SHORES AT PALMETTO BAY, LLC.
VPB-11-001

SHORES DEVELOPMENT PARKSIDE at PALMETTO BAY

SUBJECT: Palmetto Bay Charter School (K-12) - Traffic Impact Study Review

SUBJECT: Palmetto Bay Charter School (Response to School Traffic Comments)

Figure 1

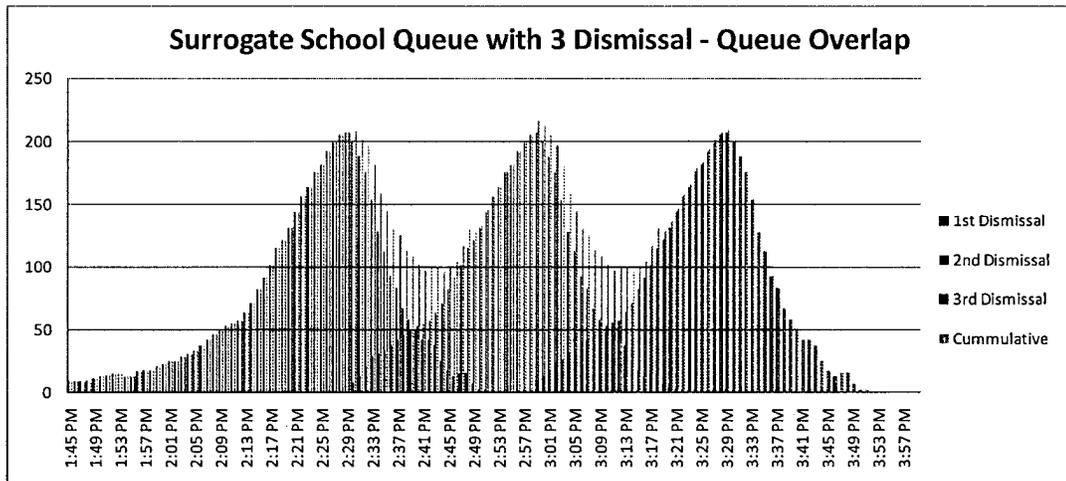
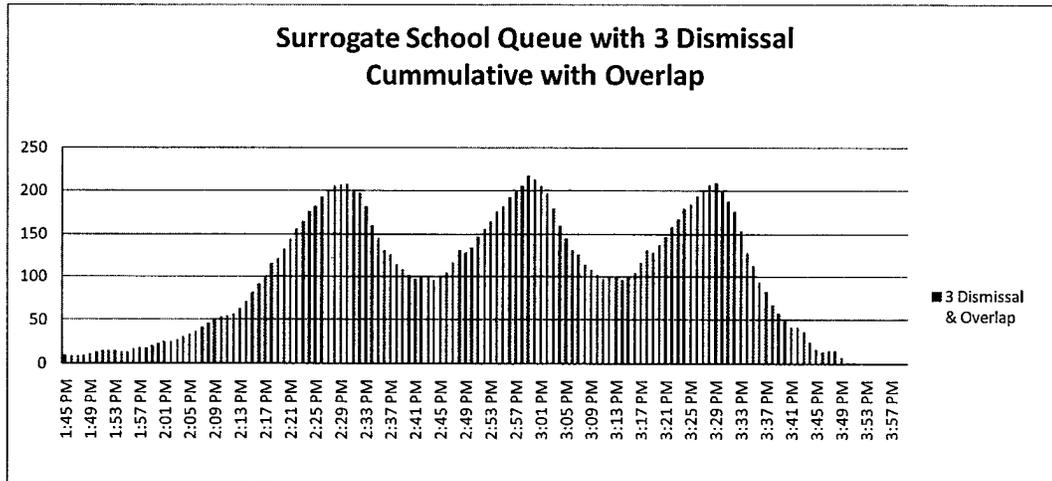
- The queue analysis data collection shows that vehicles are queued well over an hour before school dismissal during both the AM and PM periods. Therefore, an overlap of queuing should be accounted for in the analysis based on the percentage of vehicles queued using the proposed 30-minute stagger times. A sample of this stagger is included in Appendix of these comments for your review.

Since parents must wait for their child to be dismissed, those waiting in cars will queue until said dismissal. This queuing is modeled based on a surrogate school. Figure 1 includes the queuing for three (3) dismissals with an overlap. Please note, this overlap was based on the parent arriving for the student 30 minutes before their child is dismissed. It is our experience with various schools that when there are multiple dismissals; very few parents arrive 30 minutes before, as they want to avoid the previous dismissal’s queue. Finally, Figure 2 includes the cumulative queuing of the three (3) dismissals. Please note the maximum queue does not go up, rather the queuing takes longer to dissipate. This is consistent with our field data and consistent with the Miami-Dade County Public Works operation of schools with multiple dismissals and the reason why they have mandated a 30-minute interval in dismissal.

In addition, we have revised the Accumulation Assessment consistent with the surrogate school AM and PM peak queue obtained from the overlap calculations. As a result, the PM Peak Accumulation Assessment resulted in 96.24 vehicles for each dismissal, which corresponds to 107 percent being accommodated. Lastly, the analysis performed herewith is conservative and provides sufficient margin for the queuing of cars.

Figure 2: Site Plan

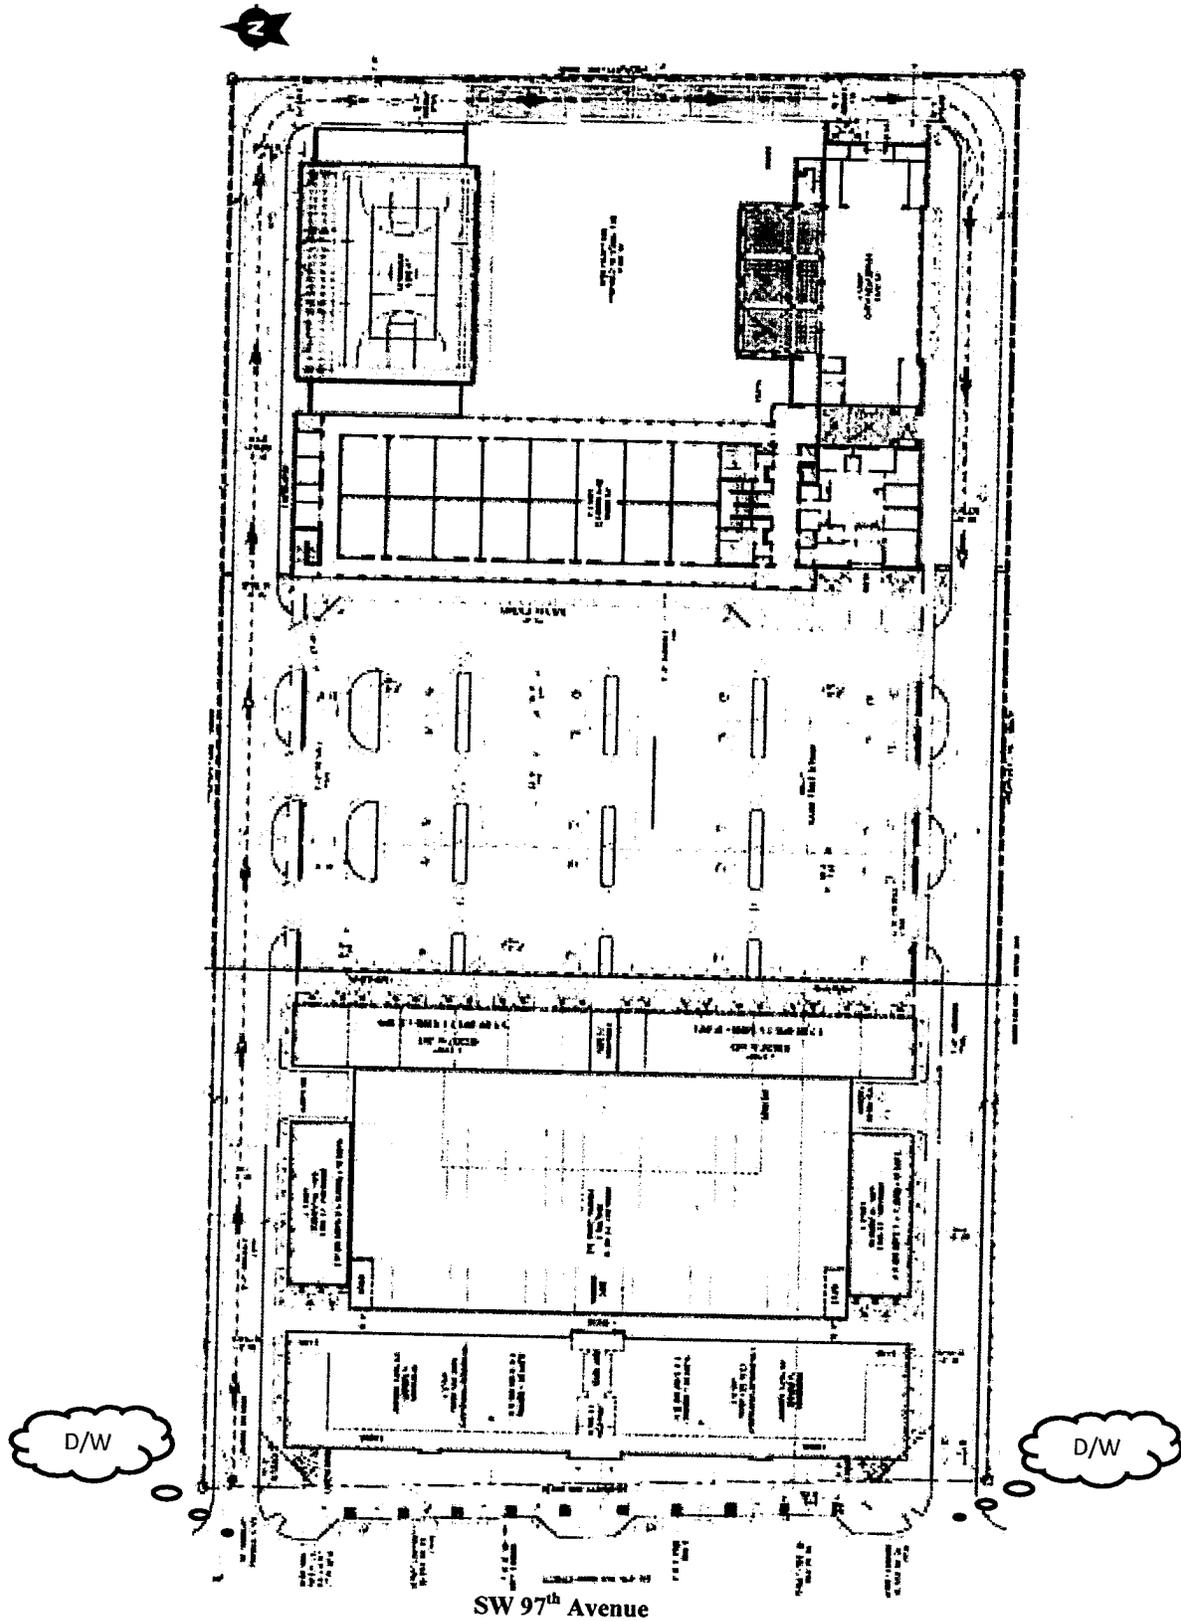
- 1. Traffic Study indicates that 103 vehicles can be stacked on the proposed site. Please show these vehicles, including dimensions on the site plan or figure.**

- 13. Will high school student vehicles access the 25 parking spaces through the proposed drop-off route? In addition, how will the surplus 26 spaces be accessed? How will they be distinguished? Please clarify.**

RGA Response: Please see the revised Site Plan provided by Civica.

RGA Response: Attached please find the revised site plan depicting the stacking area and the surplus parking utilized for vehicle stacking during the arrival and dismissal times. The parking spaces utilized for vehicular stacking will be distinguished with signs indicating their use.
